Terrace Hills-Collins School Subdivision

City of El Paso — City Plan Commission — 2/22/2018

SUSU18-00003 — Resubdivision Combination

ATTACHMENT 1

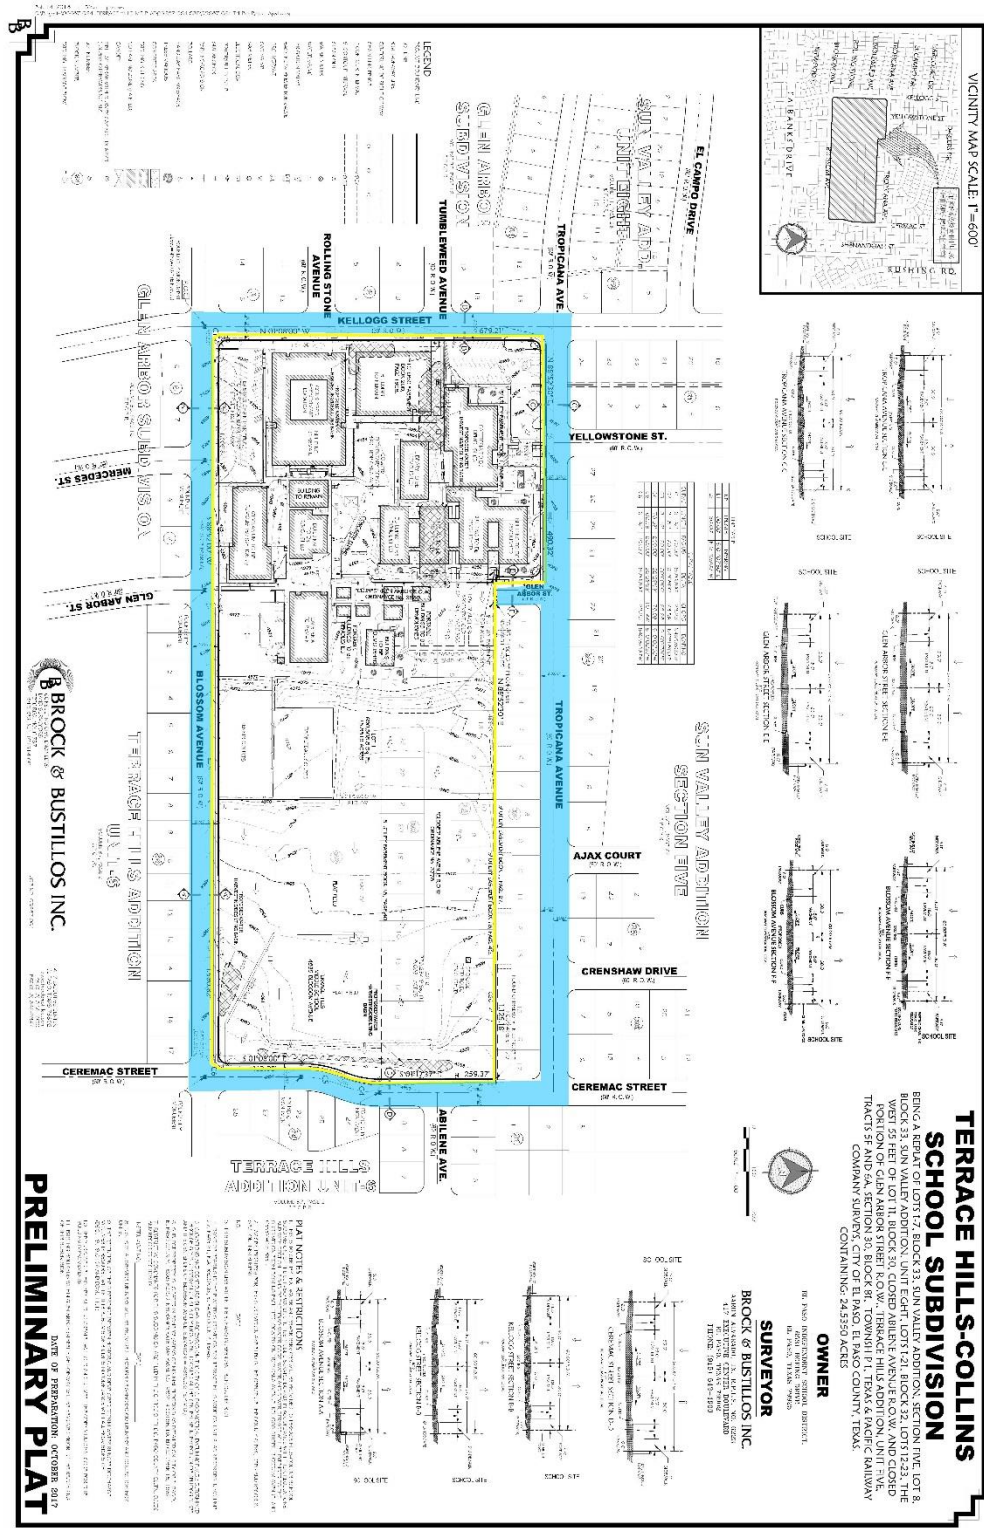
1. Verify if a private drainage easement will be required within lot 2 for some runoff flowing from lot 1. Reference document number on final plat if by separate instrument.
2. The proposed ponding areas shall have enough total capacity to hold the developed runoff for a designed 100-yr storm event. Verify that they are sized accordingly at time of construction.
3. Show proposed drainage flow patterns on the preliminary plat.
